# Work Order ID 98499

Item Name: 205 Bent Tube

DRAWING NO. D2580	TITLE 205 SKIDTUBE ASSEMBLY	REV. E	<b>DART AEROSPACE LTD ENGINEERING ORDER</b>	D.E.O. NO. D2580-E-1	SHEET NO. SHEET 1 OF 1	SCALE NTS
DRAWN <i>UP</i>	CHECKED <i>ASS</i>	MFG. APPR. <i>ER</i>	APPROVED <i>#</i>	DE APPR. <i>#</i>		
DATE 11.12.13	DATE 11.12.13	DATE 11.12.13	DATE 11.12.13	DATE 11.12.13

CHANGE ALL C'BORED WELDED CROSSBOLT SPACERS TO SWAGED SPACERS

**SECTION B-B** D5-2  
SCALE 5X

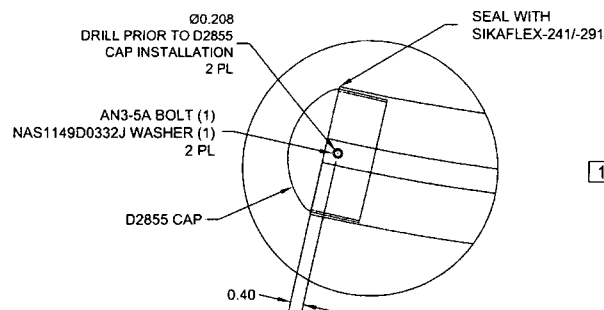
- AFTER DRILLING AND BENDING ASSEMBLY  
PERFORM THE FOLLOWING FOR Ø0.508 HOLES ONLY:
1. CHAMFER HOLE 0.050 X 45°
  2. INSERT D2579 SPACER (20 PLACES)
  3. WELD INTO PLACE AND GRIND FLUSH
  4. C'BORE D2579 SPACER TO Ø0.437 X 1.00 DEEP

1. INSERT D4202-1 SPACER, 20 PL (-041) OR 20 PL (-045) OR 25 PL (-047)
2. SWAGE TO Ø0.437 X 1.00 DEEP PER QSI 002
3. TRIM / GRIND FLUSH PER QSI 002

**SECTION B-B, F-F, I-I**  
NOT TO SCALE

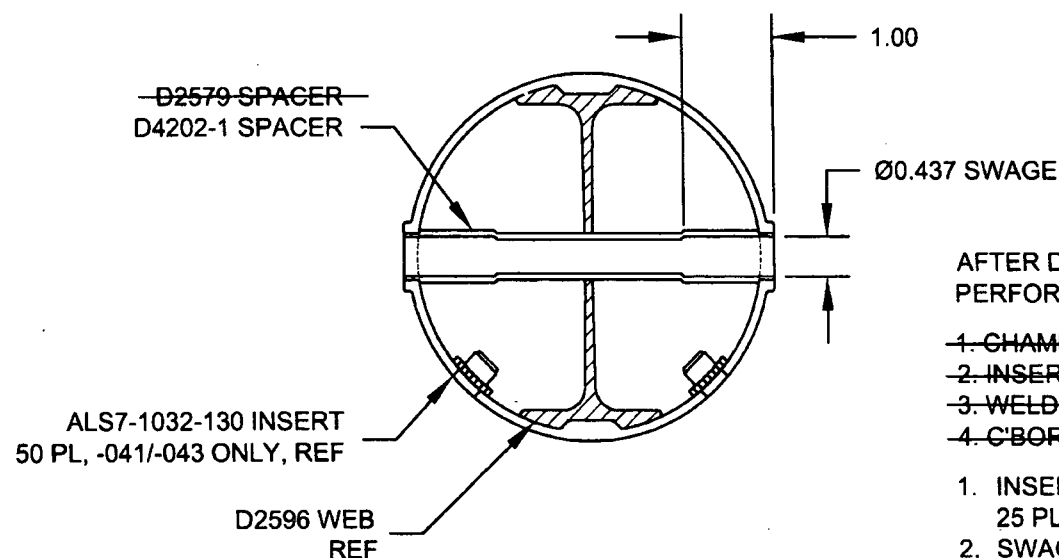
PARTS LIST IS AMENDED AS FOLLOWS:

**WAS**

QTY	QTY	QTY	PART NUMBER	DESCRIPTION
-041	-045	-047		
20	24	25	D2579	CROSS BOLT SPACER

SECTION B-B, SECTION F-F, & SECTION I-I ARE AMENDED AS FOLLOWS  
FOR ALL HOLES THAT WERE ORIGINALLY C'BORED:

**\* FOR -045 SKIDTUBE ONLY:**  
WELD 4X D2579 SPACERS PER DWG  
IN LOCATIONS MARKED "NO C'BORE".  
REF SHEET 4 OF DWG.

- ~~1. CHAMFER HOLE 0.050 X 45°~~
- ~~2. INSERT D2579 SPACER (20 PLACES)~~
- ~~3. WELD INTO PLACE AND GRIND FLUSH~~
- ~~4. C'BORE D2579 SPACER TO Ø0.437 X 1.00 DEEP~~

**IS**

4		* D2579	CROSS BOLT SPACER
20	20	25	D4202-1	SPACER
